UNITED STATES PATENT AND TRADEMARK OFFICE

10/579,284

Office Action Summary	Application No. 10/579,284	Applicant(s) SCHLEGL ET AL.	
	Examiner MARINA TIETJEN	Art Unit 3753

DETAILED ACTION

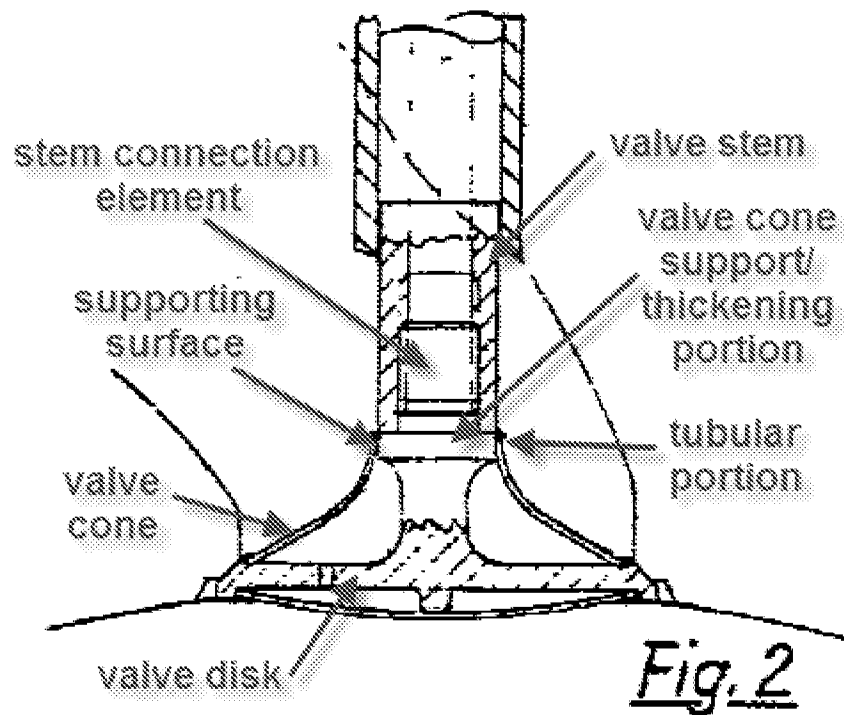
Schwaiger teaches a valve wherein a valve stem (see labeled fig. 2 below) is connected to a stem connection element (see labeled fig. 2 below) formed on a valve disk (see labeled fig. 2); wherein a valve cone support (see labeled fig. 2 below) is located at a distance from the valve disk and provided in a hollow space of a valve cone, the valve cone support being located on the stem connection element and projecting above the flat side; wherein the valve cone support includes at least one supporting surface (see labeled fig. 2 below) bearingly contacting an inner wall region of the valve cone; wherein a contour of the supporting surface complements the inner wall region; wherein the valve cone-support is formed by a thickening (as shown in fig. 2) on the stem connection element; and wherein the valve cone has at a smaller diameter end a tubular projection (see labeled fig. 2) for guiding through the valve stem or the stem connection element; wherein the valve cone-support (labeled fig. 2) forms a centering or supporting seat for the valve cone; wherein the valve cone, the valve disk and the valve stem are shaped such that the valve cone is capable of sliding over the valve stem so

the end face of the end of greater diameter of the valve cone is brought into contact with the valve disk after the valve disk is connected to the valve stem; wherein the stem connection element (labeled fig. 2) is arranged on the valve disk to fix a vertical position of the valve cone relative to the valve disk as the end face of the end of greater diameter of the valve cone is brought into contact with the valve disk; wherein the stem connection element (labeled fig. 2) is shaped such that the valve cone is capable of sliding over the stem connection element so the end face of the end of greater diameter of the valve cone is brought into contact with the valve disk after the valve disk is connected to the stem connection element; and wherein the stem connection element (labeled fig. 2) is shaped such that the valve cone, the valve disk and the stem connection element are capable of being aligned with each other before the valve cone, the valve disk and the stem connection element are materially connected, for the purpose of providing means for adding rigidity and structural support for the hollow valve cone and for the purpose of providing the ability for the valve disk and cone to be removable from the valve stem, and therefore replaceable.

Figure 3

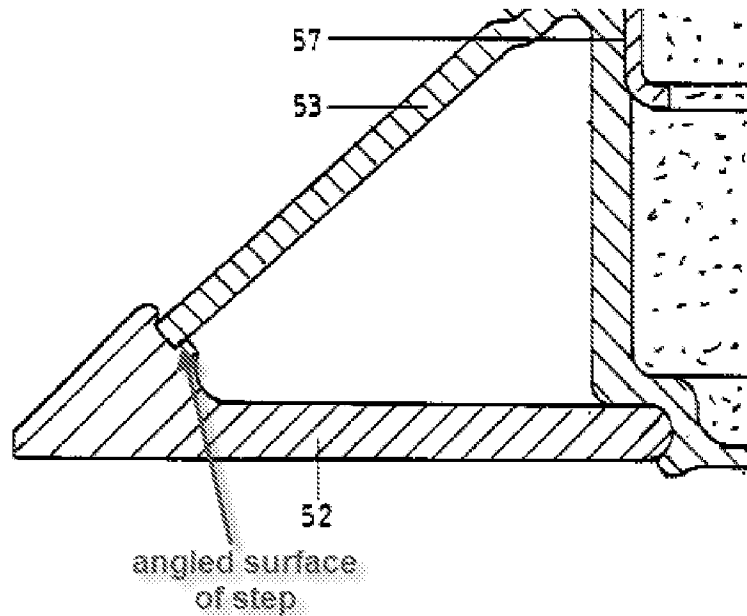
Leiber teaches a valve disk wherein the step (see labeled fig. 3) is clearly angled for the purpose of the step providing a better seating surface that contours the valve cone.

It would have been obvious to one having ordinary skill in the art at the time the invention was made to further modify Larson's invention such that the step is clearly angled, as taught by Leiber, for the purpose of the step providing a better seating surface that contours the valve cone.
